**Addendum No. 2
February 16, 2023**

Project: Harrisburg Elementary School #8
Harrisburg, South Dakota
Architecture Incorporated Project #3000

Architect: Architecture Incorporated

2) SHEET 9.21 – FLOOR PLAN – AREA A – POWER & SIGNAL

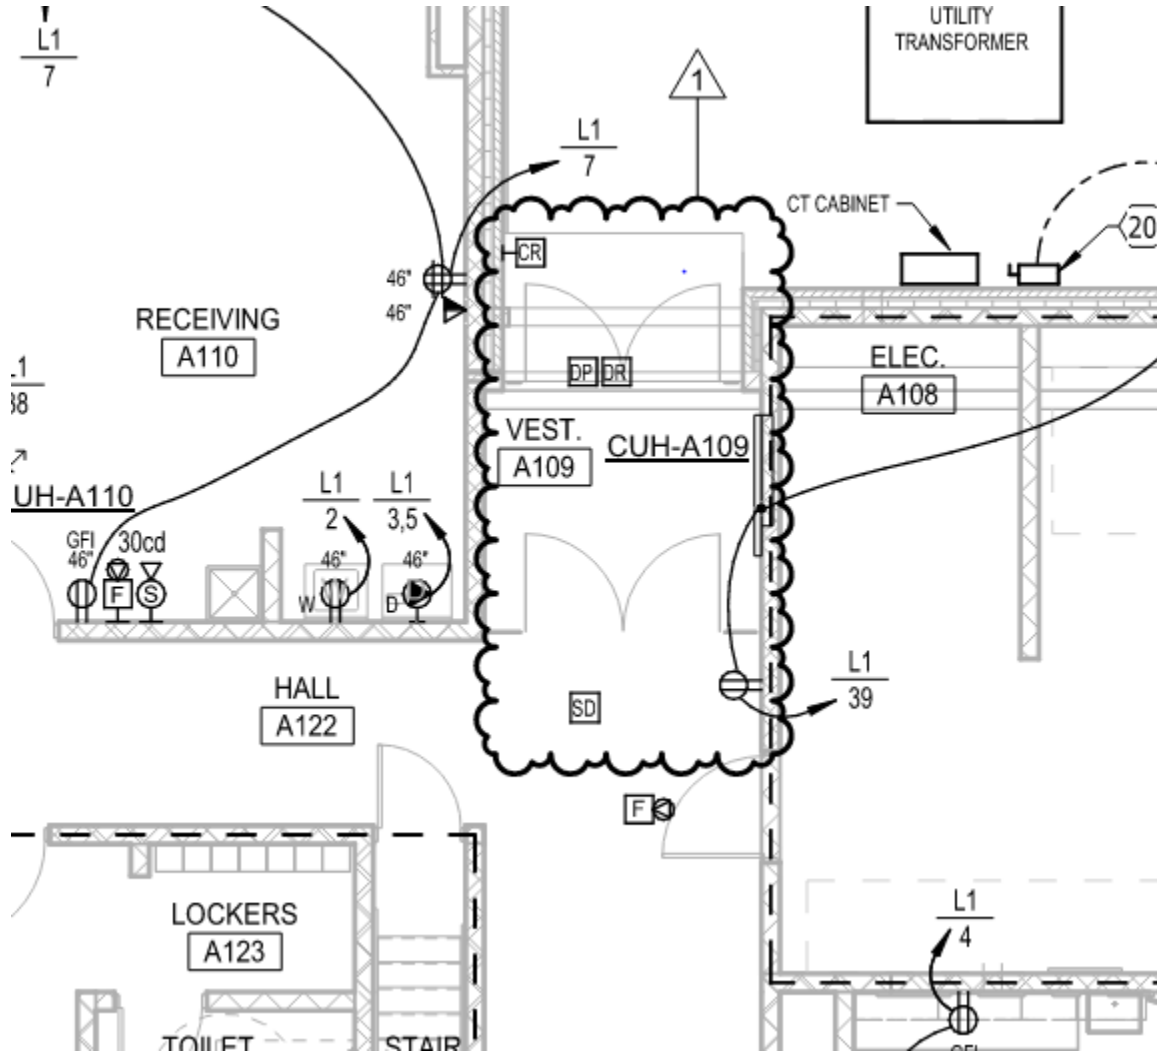
a) See clouded areas in snip below for electrical revisions in Vestibule A109.

2.31

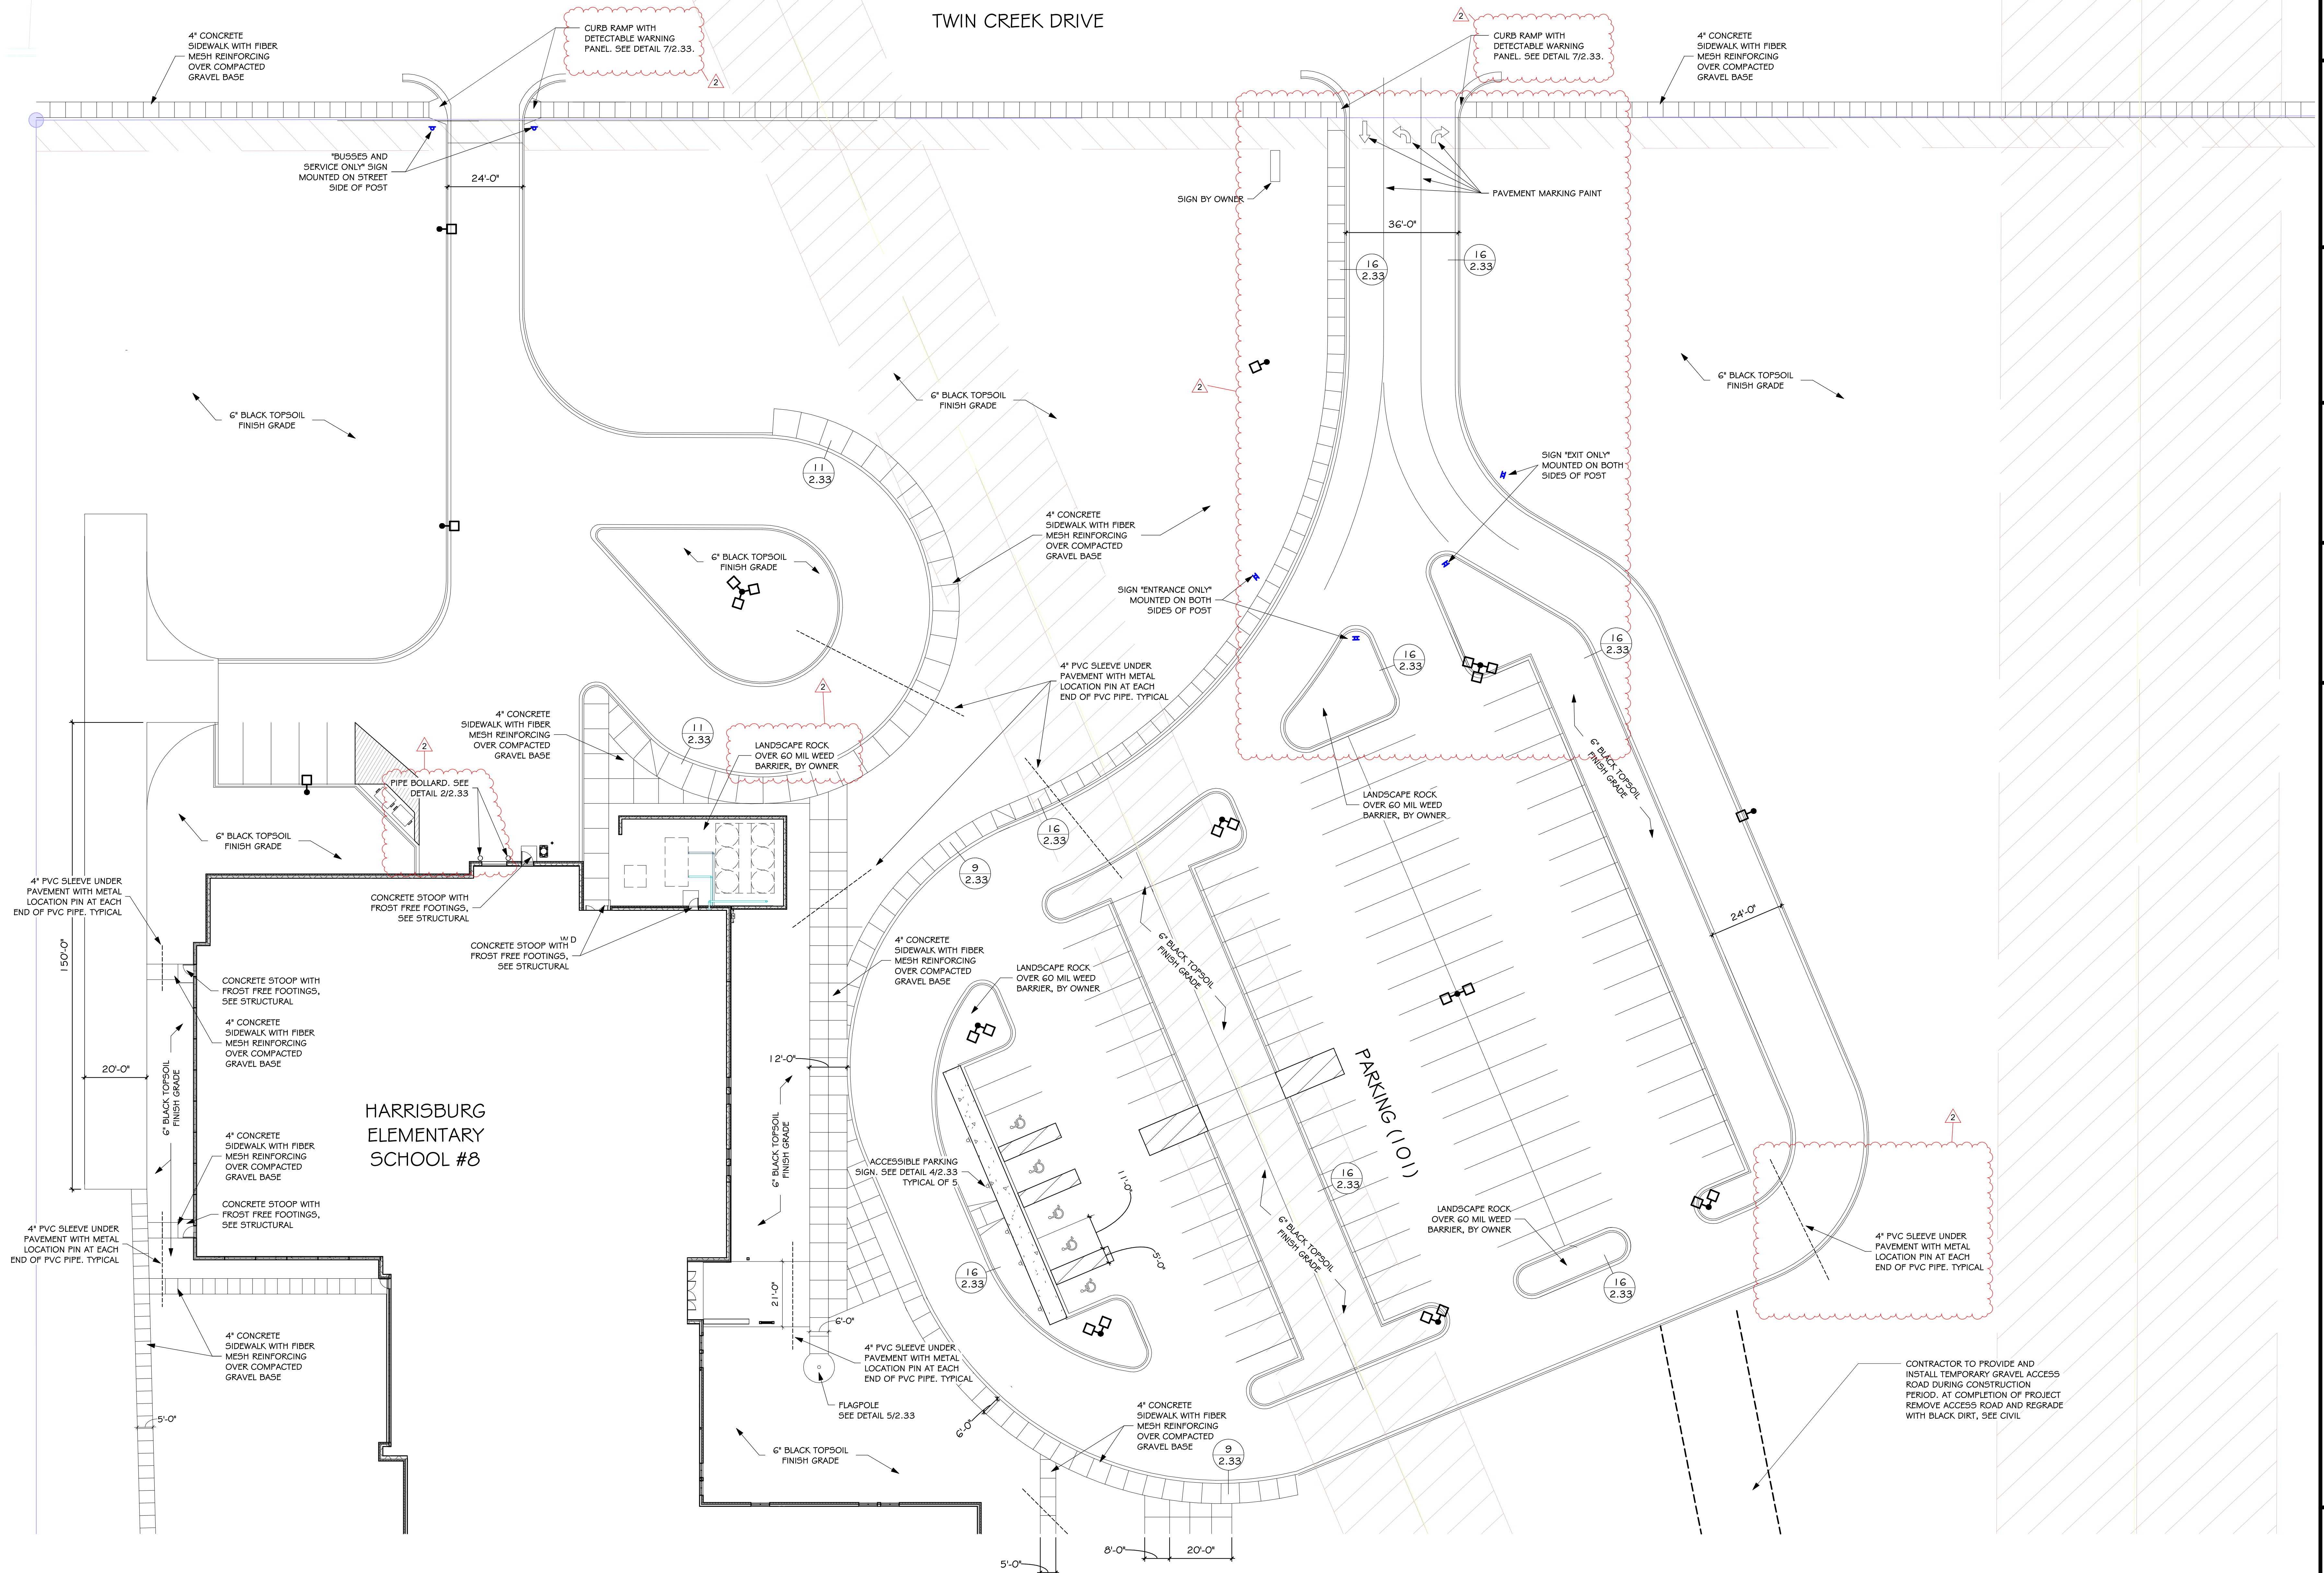
- a) Reference *revised* drawing Sheet 2.31, dated 2-16-23, attached to the end of this addendum for the following modifications:
- i) Provide a 4” PVC sleeve under the pavement at the southeast corner of parking lot; reference revised details.

- ii) Revised perimeter of landscape areas at entry/exit parking lot intersection.
 - iii) Replace keynote “~~CURB RAMP WITH DETECTABLE WARNING PANEL. SEE DETAIL 7/2.6~~” with “**CURB RAMP WITH DETECTABLE WARNING PANEL. SEE DETAIL 7/2.33**”.

- (a) The driveway width has also increased to provide for an inbound lane, an outbound left turn lane and an outbound right turn lane onto Twin Creeks Drive. Provide pavement markings as shown.

- vi) See new plan note **LANDSCAPE ROCK OVER 60MIL WEED BARRIER, BY OWNER** at exterior mechanical equipment yard.
 - vii) Omit the concrete stoop shown immediately north of overhead door opening A111-1; not required.

- viii) Provide (exterior) steel pipe bollards on either side of the overhead door opening A111-1.
 - ix) Reference miscellaneous section callouts which identify curb type(s).

2.32

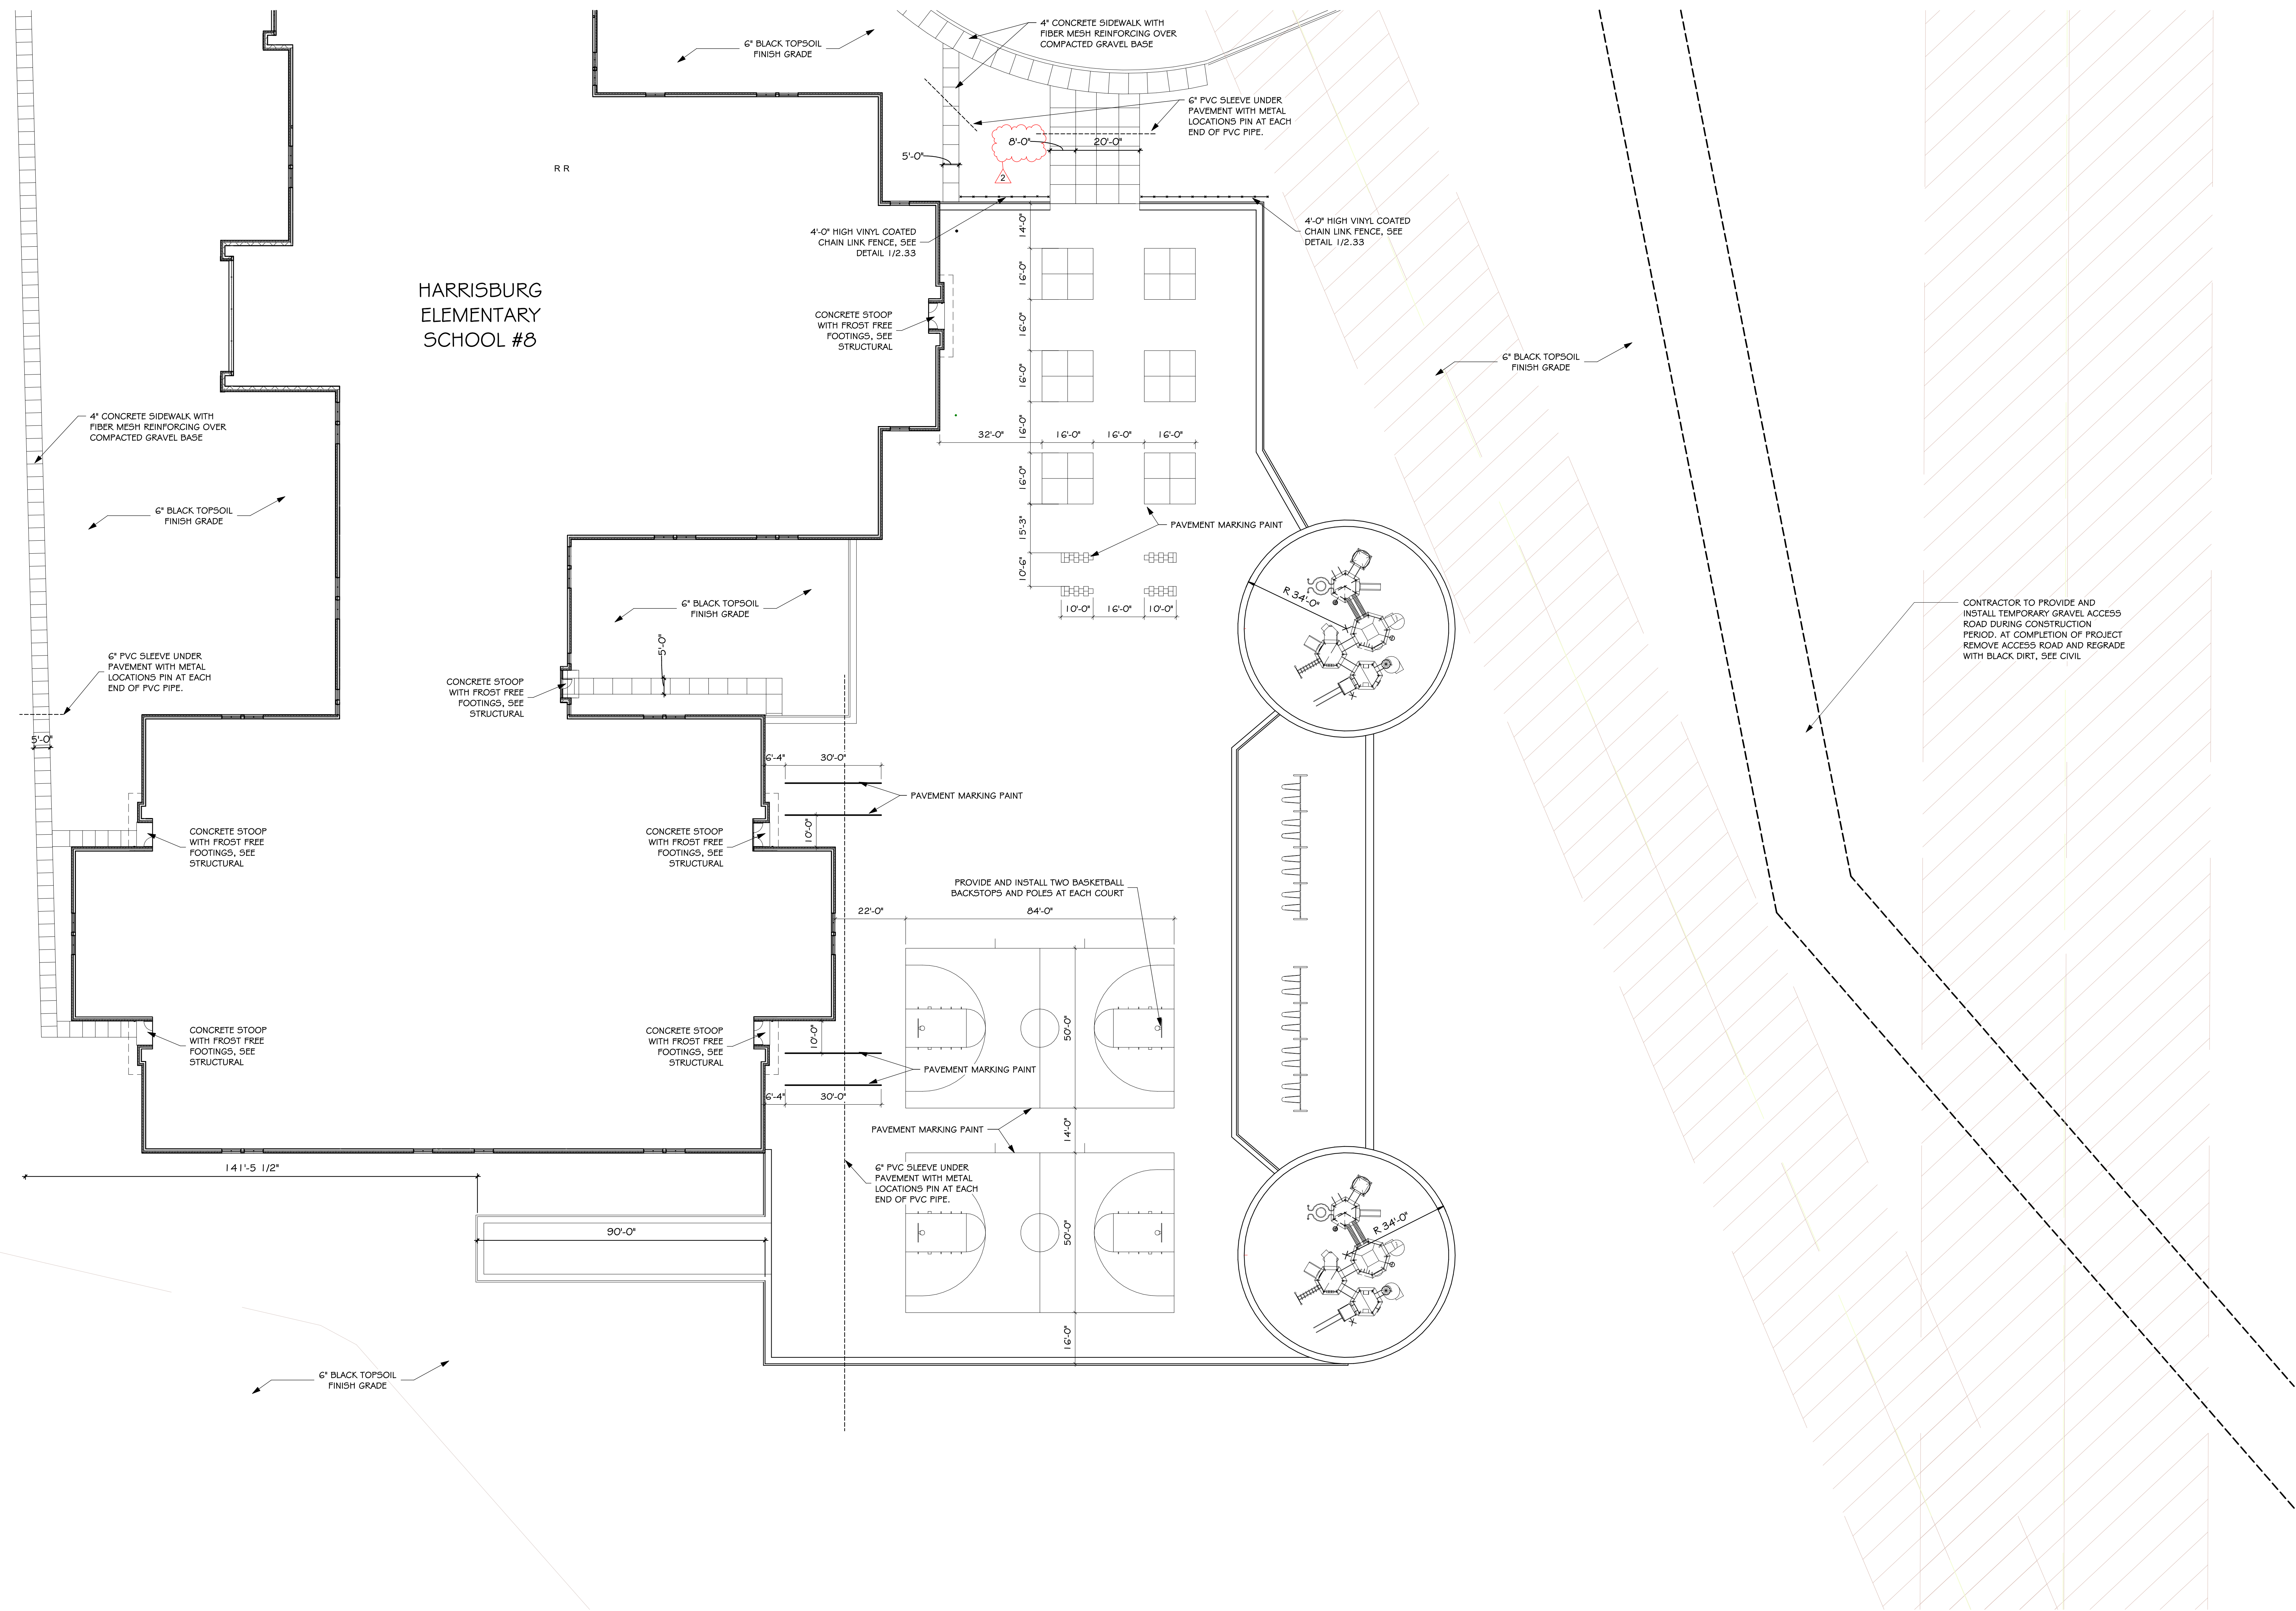
- a) Provide an 8’-0” wide x 4-inch thick strip of concrete sidewalk adjacent the west side of the 20’-0” wide playground driveway as indicated per *revised* drawing Sheet 2.32, dated 2-16-23, attached to the end of this addendum.
- b) The Contractor shall provide all playground striping as indicated per *revised* drawing Sheet 2.32, dated 2-16-23, attached to the end of this addendum. See added plan note **PAVEMENT MARKING PAINT** throughout the playground area.
